DEVELOPMENT REVIEW BOARD REPORT

SUBJECT	Villa Contento
REQUEST	<p>Request to approve preliminary plat, site plan & elevations for a 38-townhome development on 5+/- acres.</p> <p>19-PP-2003</p> <p>Key Items for Consideration:</p> <ul style="list-style-type: none">• This is a new development/subdivision at the southwest corner of McDowell Road and 85th Place.• The development will comply with the McDowell Road streetscape guidelines.• The proposed infill development provides new investment along McDowell Road that is compatible with the surrounding area.
OWNER	<p>ABS Equities LLC 602-468-9888</p>
APPLICANT CONTACT	<p>Paul Rogers AEC Consultants 602-264-1427</p>
LOCATION	<p>1550 N 85th Place</p>
BACKGROUND	<p>Zoning.</p> <p>The site is zoned Multi-Family Residential District (R-5), which allows a variety of housing unit types.</p> <p>Context.</p> <p>This subdivision is proposed on an existing 5-acre vacant lot at the southwest corner of McDowell Road and 85th Place. The surrounding area is fully developed with multi-family residential development to the north, east, and south, and office development to the west. An existing drainage corridor abuts this property to the west.</p>

VILL

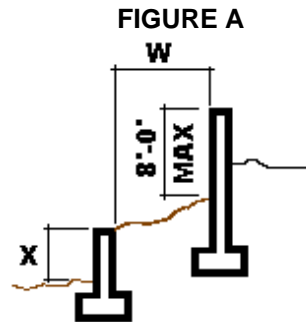
12. The retaining wall and fence wall combination (a fence wall on top of a retaining wall) adjacent to streets, washes, open space, and parks shall not have a visual height greater the 8-feet. Walls combination that have a visual height greater than 8-feet, shall be stepped or broken up through the use of multiple retaining wall as shown Figure A.

The height of any individual retaining wall, within the stepped wall combination, shall not exceed a maximum of 6-feet, “x” dimension shown on Figure A. The separation between step walls, “w” dimension shown on Figure A, shall be a minimum of 4-feet when the lower retaining wall “x” has a visual height up to 4-feet. The minimum separation, “w” dimension shown on Figure A, shall be equal to the height of the “x” dimension when the visual height of “x” is greater than 4-feet.

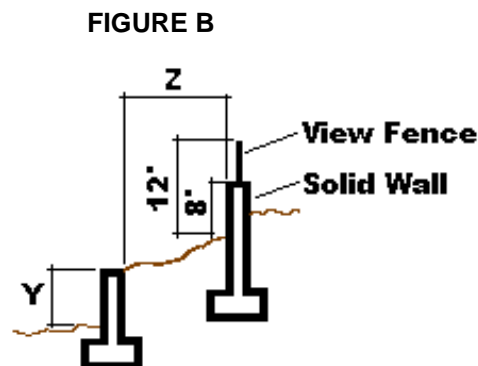
13. The retaining wall and fence wall combination (a fence wall on top of a retaining wall) adjacent to streets, washes, open space, and parks shall not have a total height greater the 12-feet, as shown Figure B. The solid wall portion of this type of combination wall shall not exceed a visual height greater than 8-feet, as shown Figure B. Walls combination that have a visual height greater than 8-feet solid wall or a total height greater that 12-feet shall be stepped or broken with additional steps.

The height of any individual retaining wall within the stepped wall combination shall not exceed a maximum of 6-feet “y” dimension shown on Figure B. The minimum separation, z dimension shown Figure B, between walls shall be a minimum of 4-feet when the lower retaining has a height up to 4-feet. The minimum separation, “z” dimension shown Figure B, shall be equal to the height of the “y” dimension when the visual height of “y” is greater than 4-feet.
